HARTING Product Change Notification

PCN/18/018/C+N

Product range: Han / Han M23 Signal

Title: Design Change of M23 Signal Hood - External

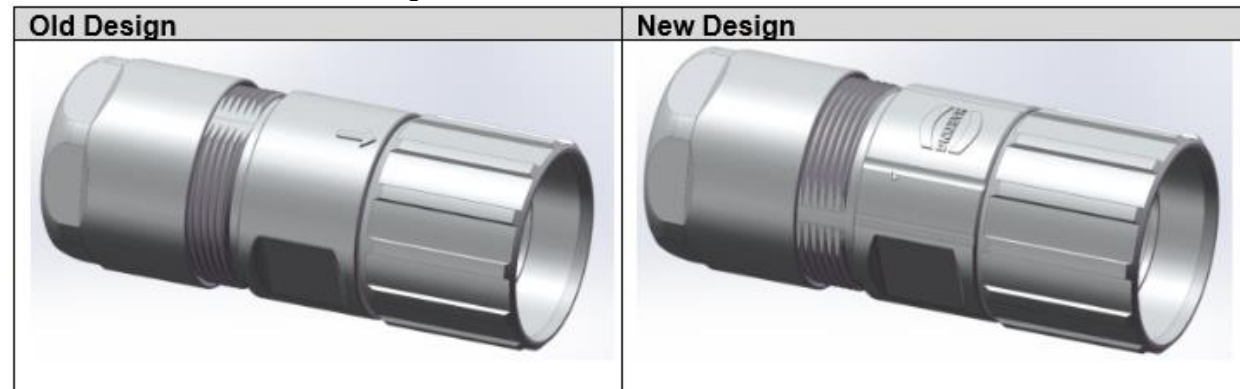
In a design optimization of the M23 Signal Hood we will change the visual alignment coding from an "arrow" to the "HARTING-logo".
